DOCUMENT 00 91 13.01
ADDENDUM NO. 1

RE: Vernal City – Roadway Rehabilitation-500 South
Project No. 2608-015

FROM: Jones & DeMille Engineering, Inc.
205 North Vernal Avenue
Vernal, Utah 84078

PL-08

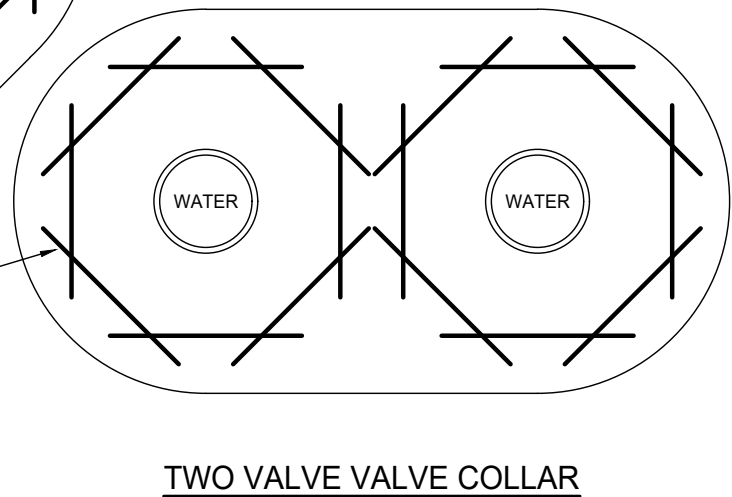
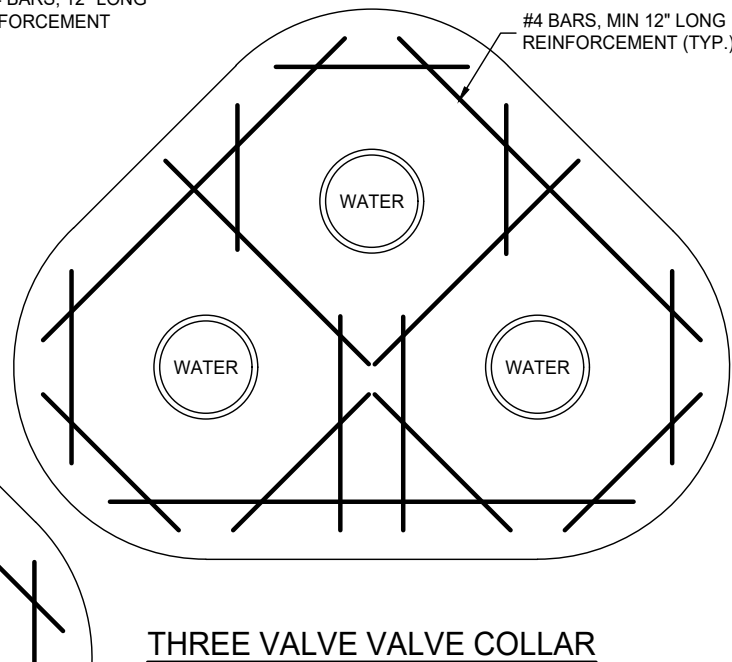
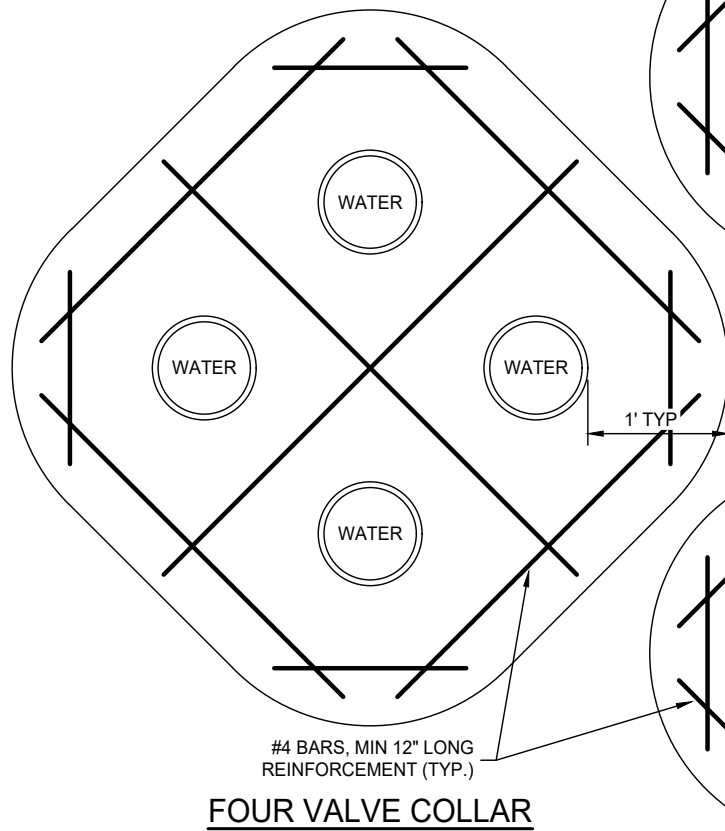
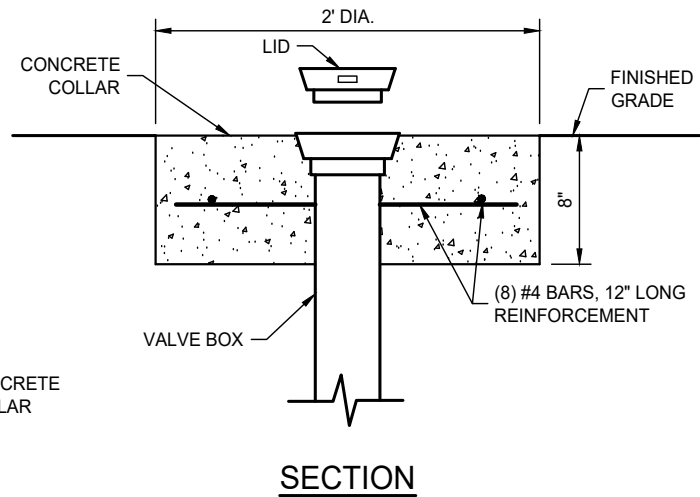
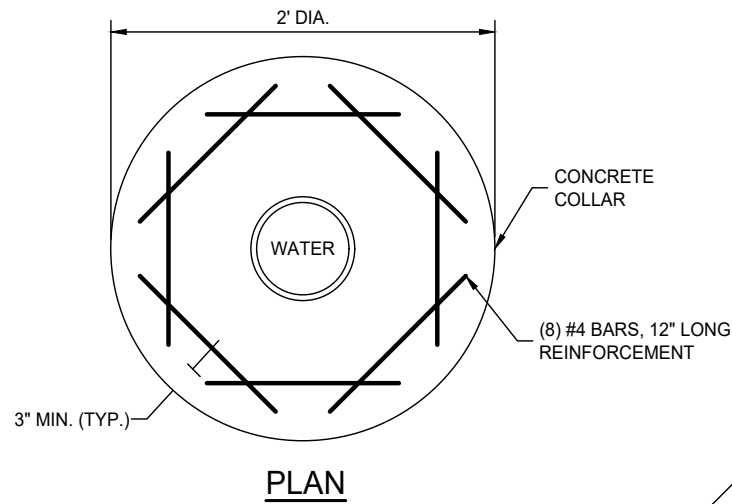
3. Sheet TS-01 – Typical Section, Updated stationing, note, and added cross slope labels.
4. Sheet PL-08 – Site Plan, Moved label that was covering valve box symbol.
5. Sheet DT-01 – Detail, Updated notes on details.
6. Sheet DT-02 – Detail, Updated note on concrete manhole collar detail.

VALVE CONCRETE COLLAR DETAIL

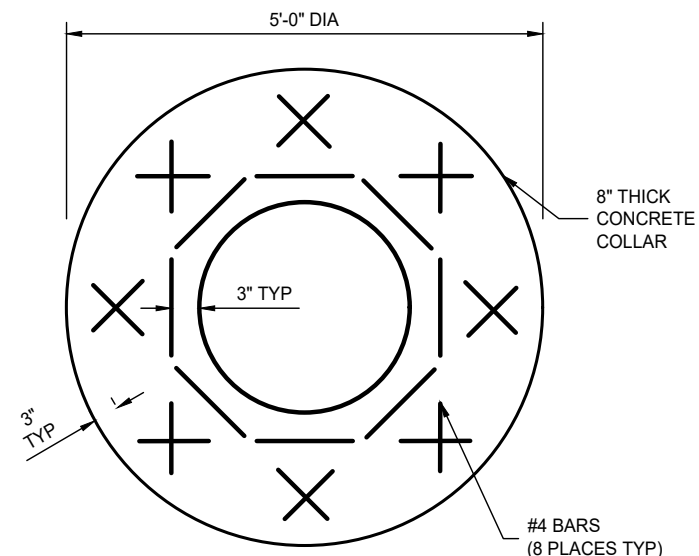
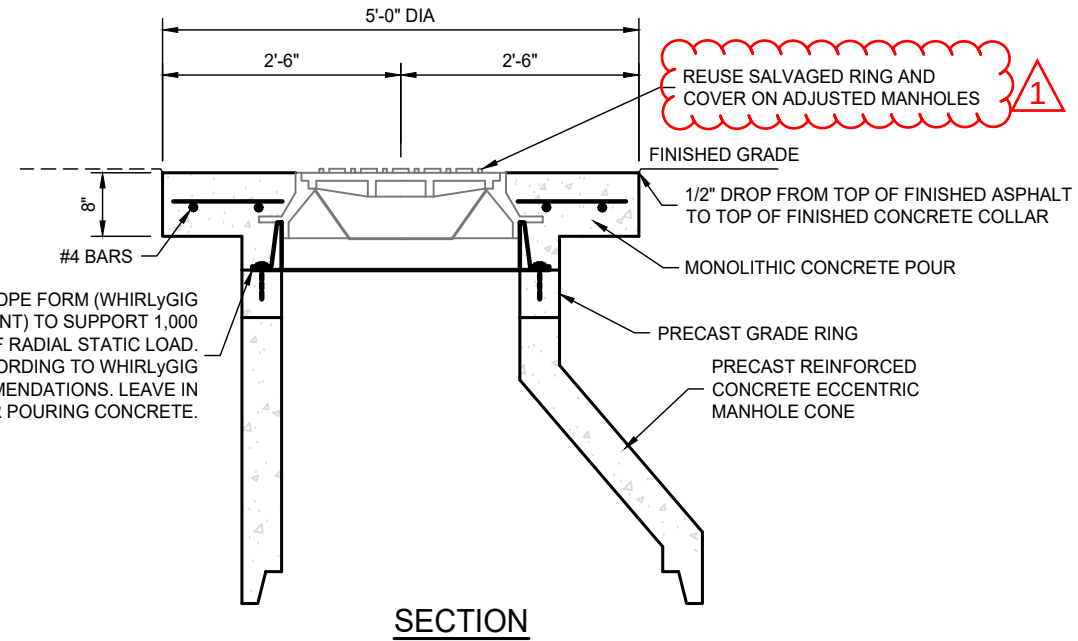
Q7: Can a fiber mesh be used in the concrete collars in place of the rebar?

A: No, the concrete collars should be reinforced according to the details shown in the project plans.
